**Verification and certification report form for
CDM programme of activities
(Version 03.0)**

Title and UNFCCC reference number of the programme of activities (PoA)	SHINE-Distribution of LED Lightbulbs in India UNFCCC Ref.No.- 10484	
Version number(s) of the PoA-DD(s) to which this report applies	07	
Version number of the verification and certification report	3.0	
Completion date of the verification and certification report	06/10/2020	
Monitoring period number and duration of this monitoring period	First (12/01/2020- 15/03/2020)	
Number and version number of the monitoring report to which this report applies	Number: 01 Version: 3	
Coordinating/managing entity (CME)	Brightspark Energy Private Limited	
Host Parties	Host Parties of the PoA	Is this a host Party to a CPA covered in this report? (yes/no)
	India	Yes
Applied methodologies and standardized baselines	AMS-II.C- Demand-side energy efficiency activities for specific technologies, Version 15.0	
Mandatory sectoral scopes	Sectoral Scope 3: Energy demand

Average Daylight Variation- North & East India

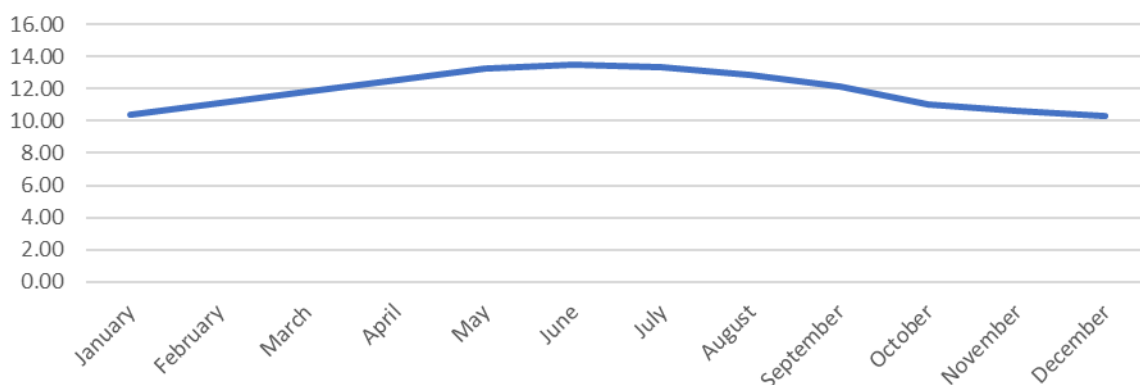
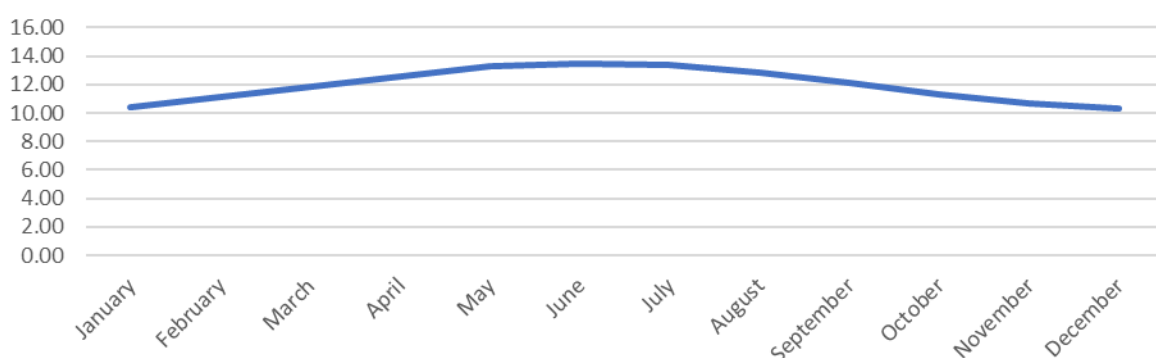
CL ID	05	Section no.	E.3.4.2	Date : 17/08/2020
Description of CL				
CME shall clarify how each of the CPAs meet the condition that operating hours during the project are equal to the operating hours in the baseline since there was no information on the operating hours in the baseline equipment.				
Project participant response				Date : 04/09/2020
The CME wishes to state that in line with clarifications SSC_740 and paragraph 28 of the 'Report of the Twenty-fifth meeting of the Small Scale Working Group' ⁶ , it had the option to monitor the operating hours of either the project equipment or the baseline equipment for calculation of baseline emission and/or project emission. The CME chose to monitor the operating hours of baseline lamps for a period of 90 days at representative households to determine the operating hours of ICLs and the same value was used for establishing the operating hours of LEDs that were distributed under the PoA to replace baseline ICLs. Here the CME also wishes to add that as there could be a tendency on the part of users to operate the project LEDs longer on account of its longer life, hence in order to get the conservative operating hour value, the run time meters were installed on baseline ICLs. The CME has submitted the baseline operating hours data to the verifying DOE.

Documentation provided by project participant				
DOE assessment				Date: 07/09/2020
The data analysis sheets for each of the CPAs which recorded the operating hours of the baseline equipment for a period of 90 days were reviewed and it was confirmed that CME has followed the requirement of monitoring the operating hours of either the project equipment or the baseline equipment as stated in clarifications SSC_740 and paragraph 28 of the 'Report of the Twenty-fifth meeting of the Small Scale Working Group'.				
In-line to para 22, page 8 of the applied methodology for parameter O _i CME has ensured that there will be no change in the operating pattern of the user with the replacement of ICL to LED. Thus, the monitored value of operating hours can be used for both baseline lamps and project lamps.				
CME's approach of measuring the operating hours value for baseline lamps was found to be acceptable and conservative as due to the energy saving and longer life property of the LEDs it could have been possible

For determining seasonal variation, the CME divided the entire year on the basis of seasons. The months corresponding to each season was determined in line with Government of India classifications and are thus
